Access Compliance Report

Public Rights-of-Way

Intersection ID: 48195	Main Street: BLAKENEY CENTRE DR	Cross Street: REA RD	Location: W
ADA ID: C5BA69536EC6	Ramp Type: BlendTrans2	Initial Pass/Fail: Fail	Overall Compliance: No
Codes/Mitigation Info/Possible Solution		Field Measurements/Component Compliance	
Severity Score: 8.75

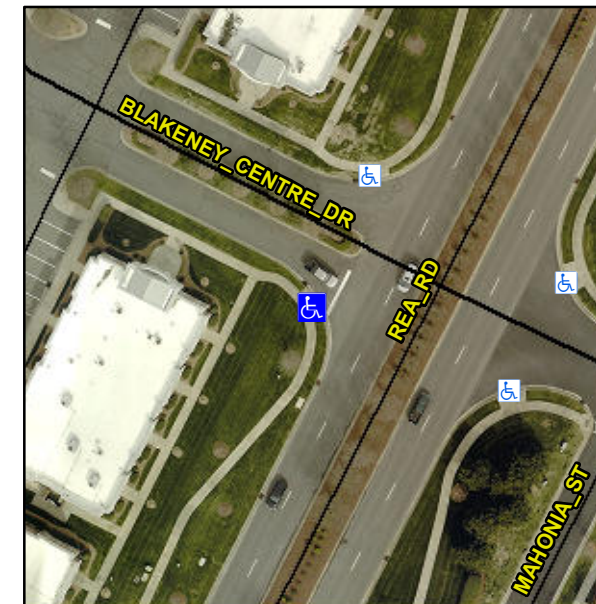
Remove & Replace Curb Ramp With Two New Directional Ramps or Equivalent.

Not Found, R304.5.1
